## Product Change Notification / SYST-18WWYC201

Data Sheet - KSZ8081RNA/RND - 10Base-T/100Base-TX PHY with RMII Support Revision

**Description of Change:** Revision includes:

**FIGURE 1-1: SYSTEM BLOCK DIAGRAM**

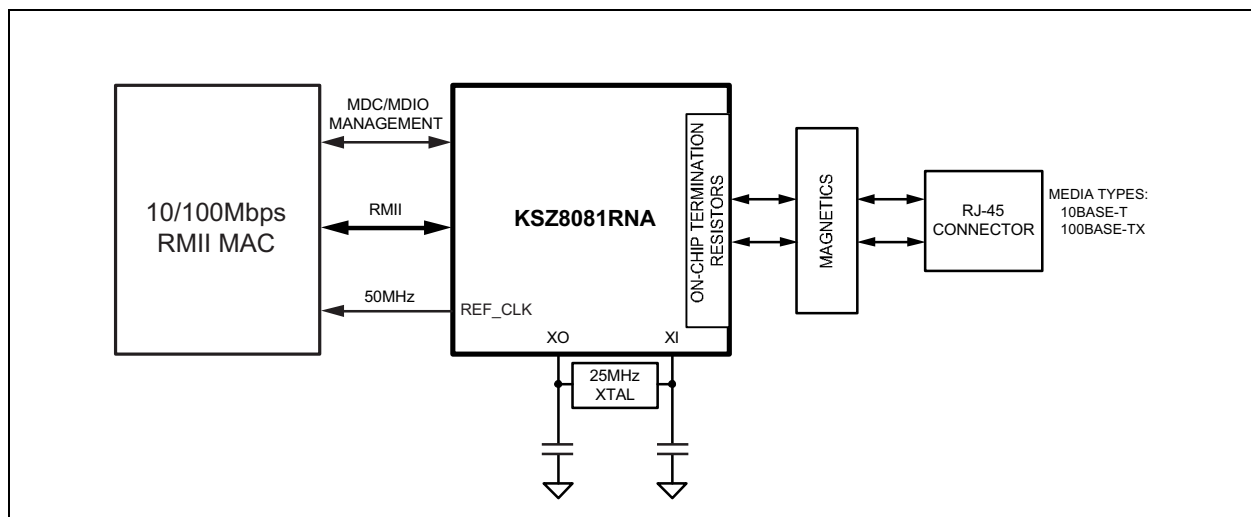
1. Figure 1-1: Updated figure to remove capacitor values.
2. Table 2-1: Updated description of Pins 8 and 16 to indicate RND crystal limitation.
3. Section 3.0: Updated 5th paragraph for clarity
4. Section 3.2.2.1: Updated bullet pointed text to indicate RND crystal limitation.
5. Figure 3-2: Updated figure to remove RND label and capacitor values.
6. Table 4-2: Added Bit 18.6 and added note to Bit 1F.7 for RND crystal limitation.
7. Section 10.0: Updated introductory text for RND crystal limitation.
8. Figure 10-1: Updated figure to remove capacitor values.
9. Section 11.0: Minor edits to introductory text for clarity.

DS00002199E (07-02-21)	Global	Updated data sheet metadata to reflect the correct contents of this document.
DS00002199F (10-18-21)	<a href="#">Figure 1-1</a>	Updated figure to remove capacitor values.
	<a href="#">Table 2-1</a>	Updated description of Pins 8 and 16 to indicate RND crystal limitation.
	<a href="#">Section 3.0</a>	Updated 5th paragraph for clarity.
	<a href="#">Section 3.2.2.1</a>	Updated bullet pointed text to indicate RND crystal limitation.
	<a href="#">Figure 3-2</a>	Updated figure to remove RND label and capacitor values.
	<a href="#">Table 4-2</a>	Added Bit 18.6 and added note to Bit 1F.7 for RND crystal limitation.
	<a href="#">Section 10.0</a>	Updated introductory text for RND crystal limitation.
	<a href="#">Figure 10-1</a>	Updated figure to remove capacitor values.
	<a href="#">Section 11.0</a>	Minor edits to introductory text for clarity.
